APPENDIX A

NOTICE OF PREPARATION AND INITIAL STUDY; RESPONSES TO THE NOTICE OF PREPARATION AND INITIAL STUDY; MAILING LIST FOR THE NOTICE OF PREPARATION AND INITIAL STUDY

Subject: Notice of Preparation of a Draft Environmental Impact Report

Project Title: Wal-Mart Supercenter at Canyon Crossings - Planning Cases P03-1313 (EIR), P04-0314 (Conditional Use Permit), P03-1213 (Street Vacation) and P05-0397 (Design Review)

Site Plan

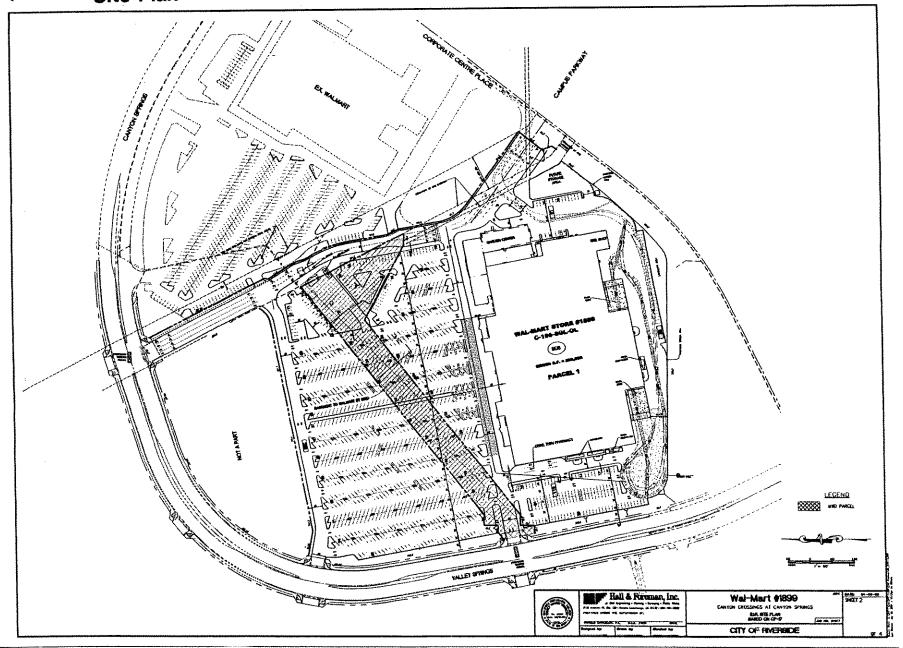
2. As shown on the grading plan (Sheet 3) and illustrated on the MWD profile exhibit plan, the modified designed grade for the proposed parking and access driveway within our fee right-of-way would require cuts of up to 4 feet and additional fill of up to 1 foot over our pipeline. With this proposed grading, our pipeline would have a resulting cover ranging from 4.5 to 10 feet, which is within the acceptable design cover limits of our pipeline for AASHTO H-20 loading in this area.

- 6. As stated on the grading plan (Sheet 3) and on the MWD profile exhibit plan, our manhole, air release and vacuum valve structure (Box Springs Feeder Station 1+73) will need to be adjusted to accommodate the approved change in grade surrounding this structure. Metropolitan will consider allowing the project contractor to perform the adjustment of this structure under Metropolitan's supervision and per our standards. All costs associated with the adjustment of our structure must be borne by the project proponent.

- 7. Metropolitan must have continuous vehicular access at all times for regular patrolling and maintenance, as required. However, the layout of the proposed parking spaces and associated planters and curb and gutter, as shown on the site plan (Sheet 2), grading plan (Sheet 3) and utility plan (Sheet 4), will inhibit our vehicular access along our right-of-way.

- 9. The locations of the parking light poles are generally acceptable where they will be installed no closer than 20 feet from the centerline of our pipeline, as shown on the site plan (Sheet 2). However, any proposed electrical conduits associated with these light poles must be encased in a minimum of 3 inches of red concrete when installed over our pipeline. Please note that should Metropolitan need to do any work in this area, the removal and reinstallation of these light standards would be the responsibility of the property owner, i.e., Wal-Mart

- 11. The grading plan (Sheet 3) indicates a proposed retaining wall that is planned directly adjacent to the southwesterly edge of our triangular shape fee right-of-way. As illustrated in Section "D-D" on this plan, we note that no part of the wall, including footings, will encroach into our right-of-way.

- 13. The utility plan (Sheet 4) indicates a proposed 36-inch storm drain line that will cross our fee right-of-way. There appear to be no conflicts where this storm drain will cross over our pipeline with approximately 1.3 feet of vertical clearance, as shown on the MWD profile exhibit plan. Please ensure that this designed clearance is maintained once your proposed storm drain has been installed over our pipeline.
